POST DETAILS
RIPTON
CCS CONSTRUCTORS, LLC

PROJECT NO. FM010-1(42)
DWG. NO. 1 OF 1

FM010-1(2)
RIPTON

20 REQ'D. RAIL POST MARK "P1"

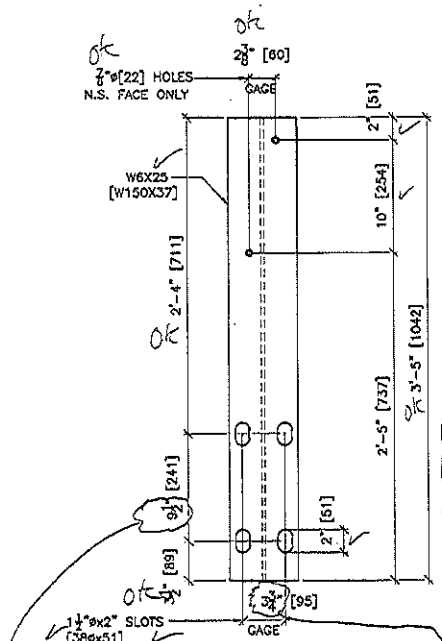
Please find a revised shop drawing attached for the Ripton bridge rail posts. We have verified that the vertical spacing between anchors in the field is closer to 9 ½" than it is to 10". Also, the gage of anchors in the field varies somewhat and tends to be slightly larger than 3 5/8". I had the fabricator include both metric (SI) and US Customary units so that people can easily verify dimensions in the field with readily available tape measures, and so that structures can easily compare dimensions to the standard.

RECEIVED
CK'D BY SGF OK'D BY SGF
MAR 18 2011
RESUBMIT _____ APPROVED AS NOTED
BY Shemard G. Jones DATE 3-18-2010

APPROVED AS NOTED PER ANDY'S EMAIL TO MARK MACKINTOSH ON MARCH 16, 2011 @ 3:28 PM
COPY IN CLOUD ABOVE.
Shemard G Jones
3-18-2011
